ADDENDUM NO. 1

PROJECT NAME: Legacy High School BB - SB Renovations

CLIENT NAME: Mansfield ISD

ADDENDUM DATE: Tuesday, April 29, 2025

F2.05

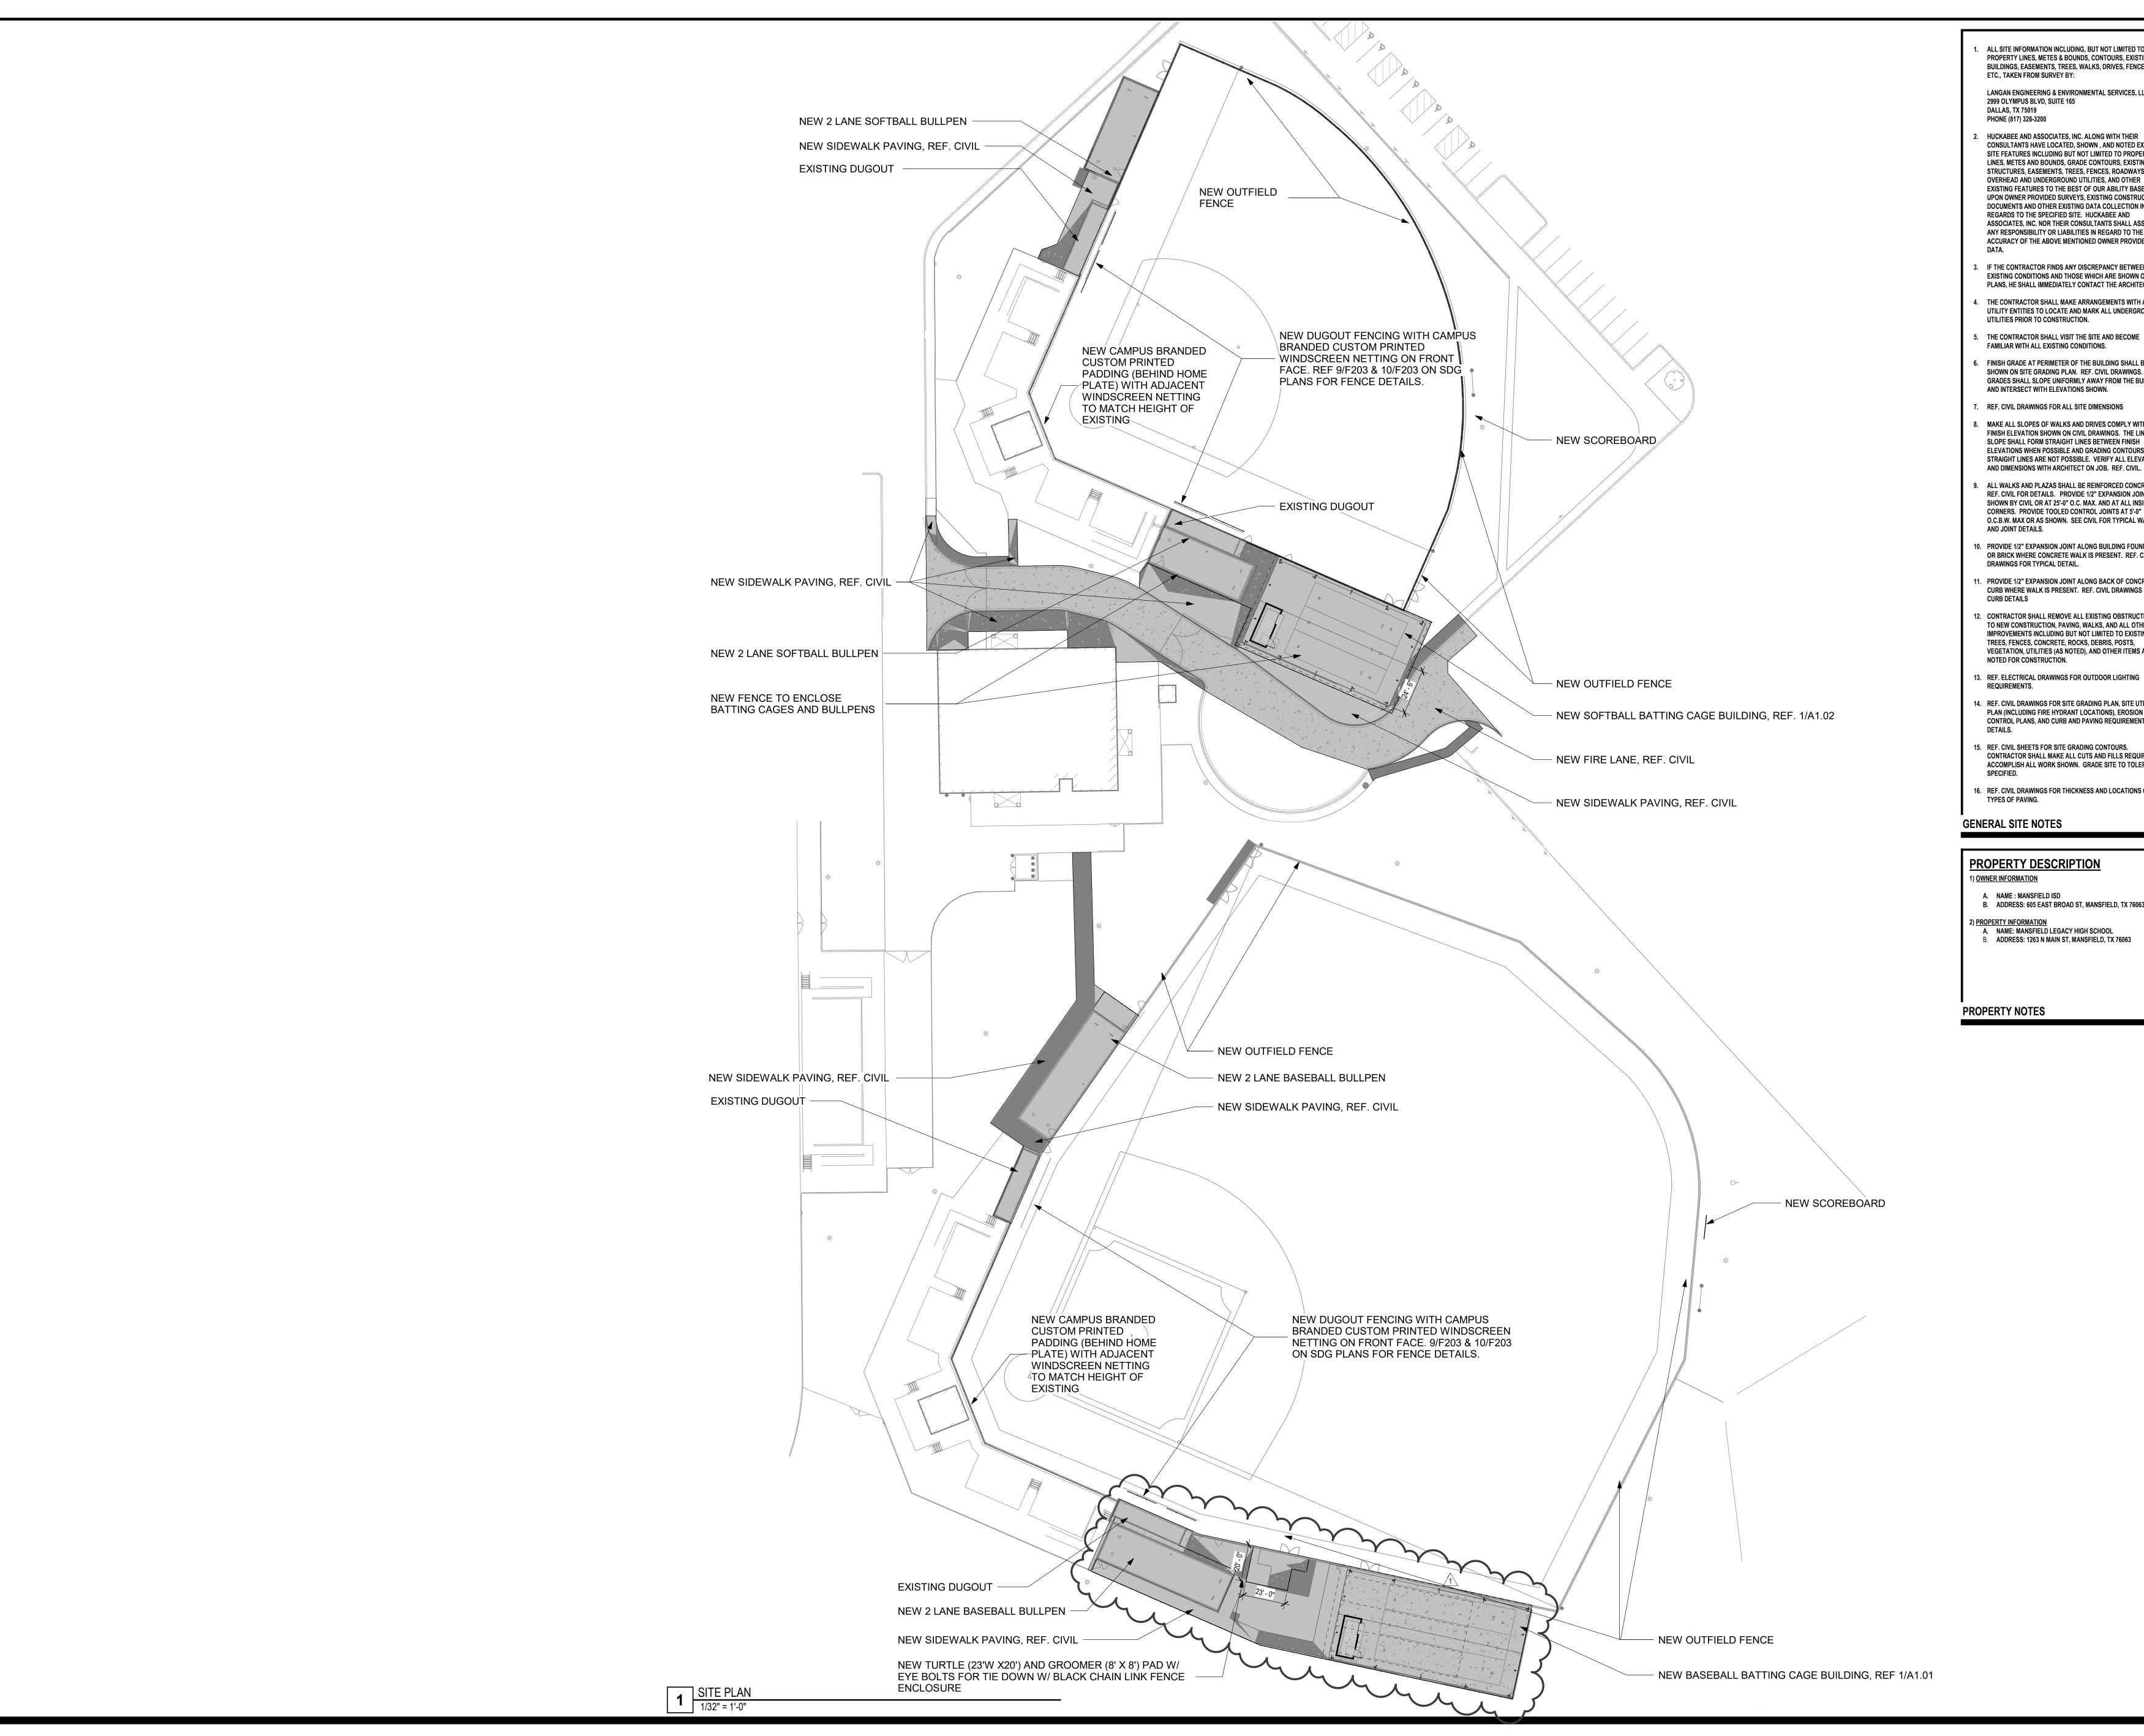
AD No 1, Sports Item 4: To the Drawings, Sheet F2.05,

4) REMOVED LEGACY BRONCOS FIELD TURF LETTERS FROM UP EACH BASELINE AND ADDED LEGACY TURF LETTERS BEHIND HOMEPLATE ON BASEBALL FIELD

ARCHITECTURAL SITE PLAN

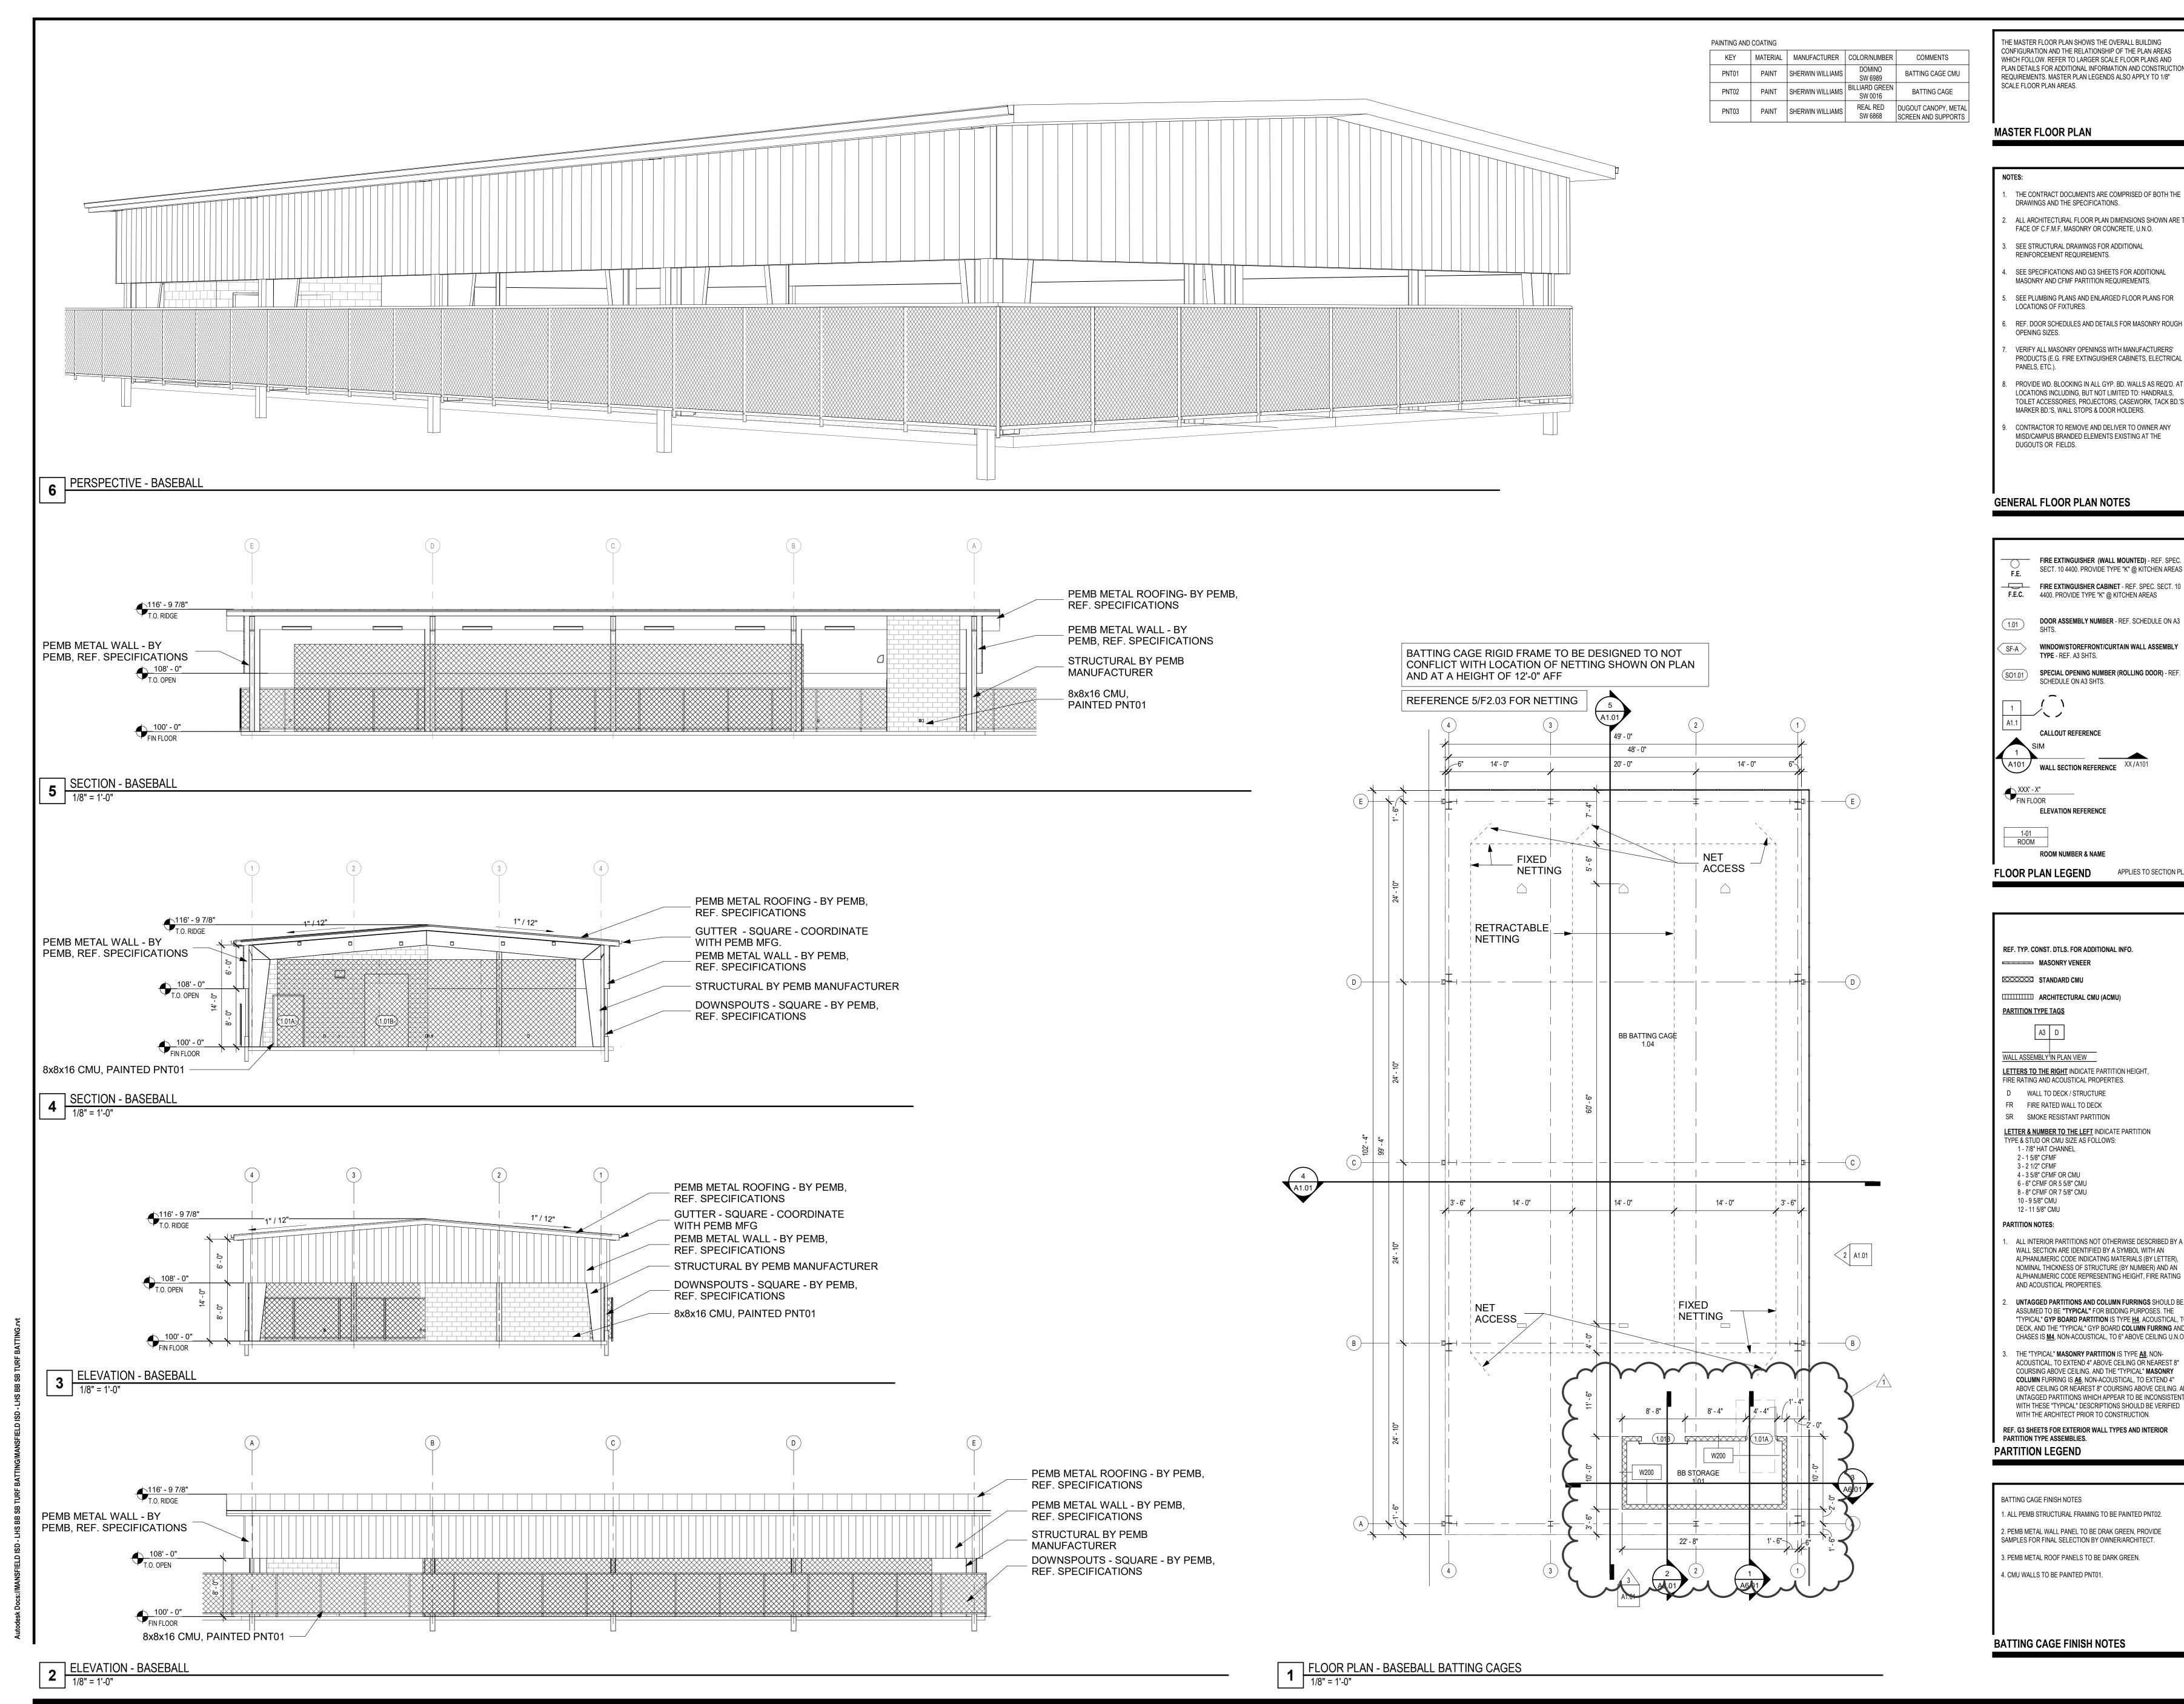
AD No 1, Arch. Item 3: To the Drawings, Sheet AS1.01, "SITE PLAN,"

1) Moved the Baseball Batting Cage Fence out to help clearly show it is not attached to the structure of the batting cage building. Refer to attached drawing AS1.01.

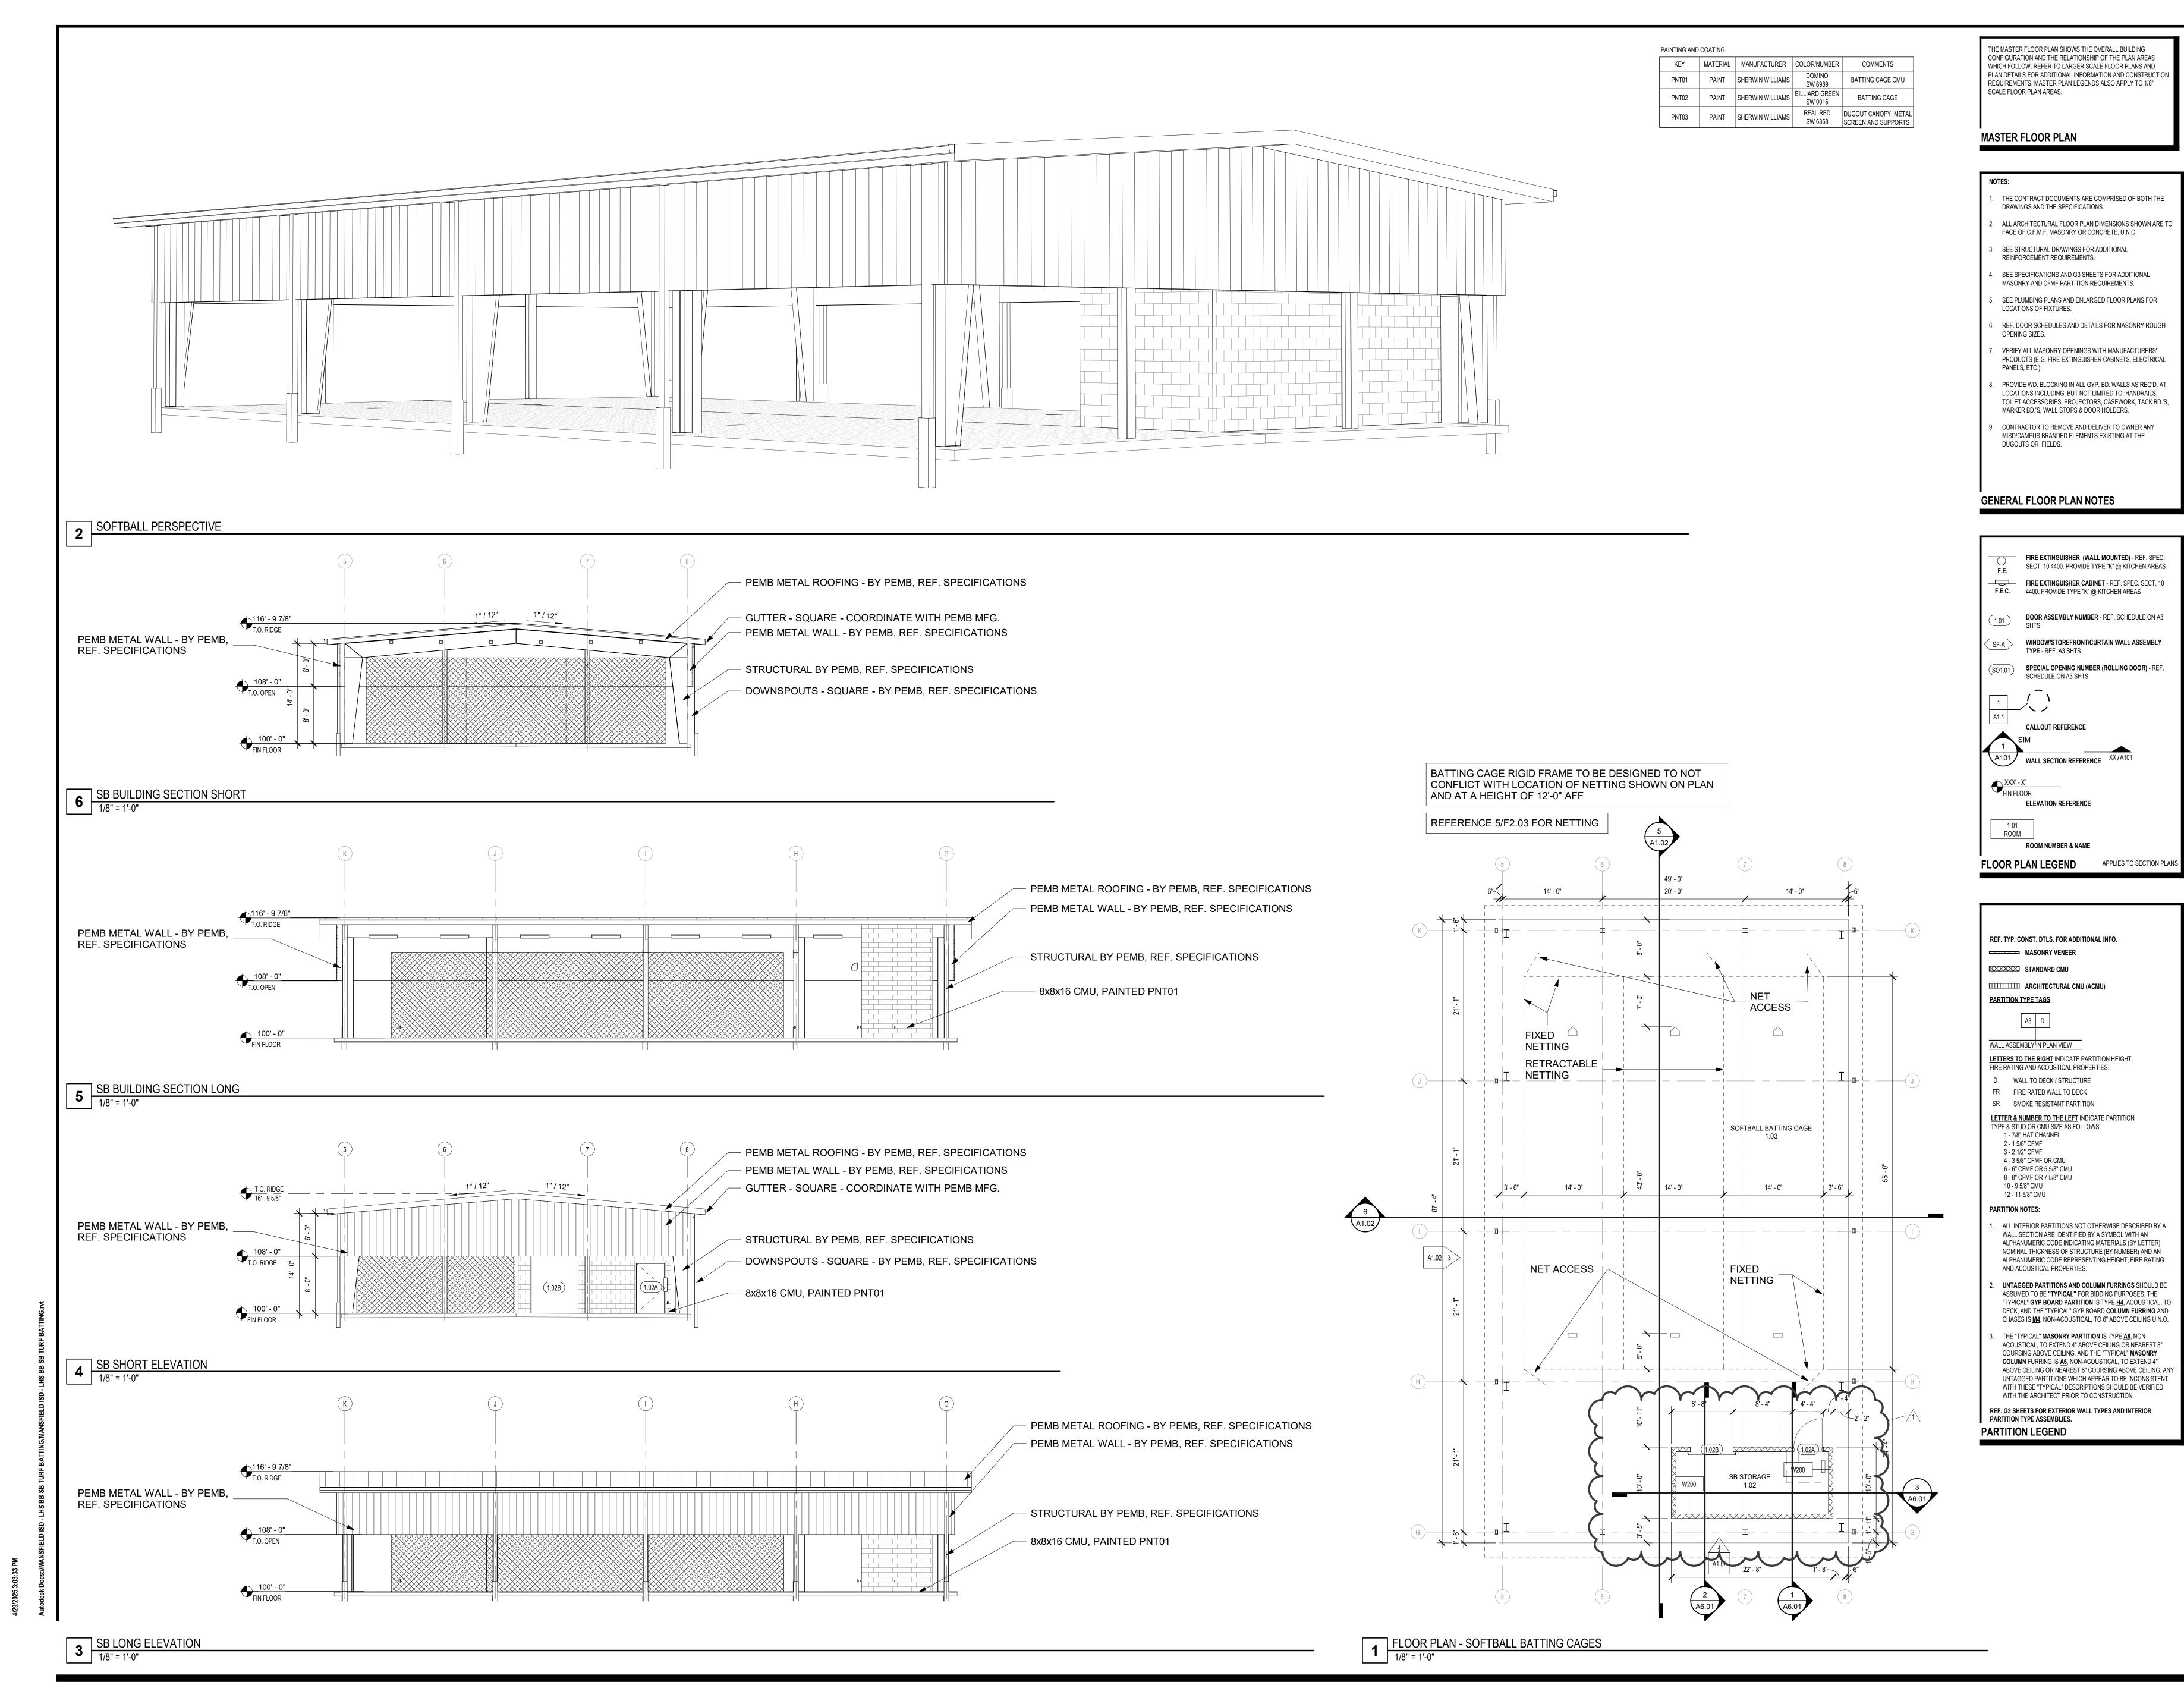
AD No 1, Arch. Item 4: To the Drawings, Sheet A1.01, "FLOOR PLAN - BASEBALL BATTING CAGES,"

1) Moved the Baseball Storage to sit over structural footings. Refer to attached drawing A1.01.
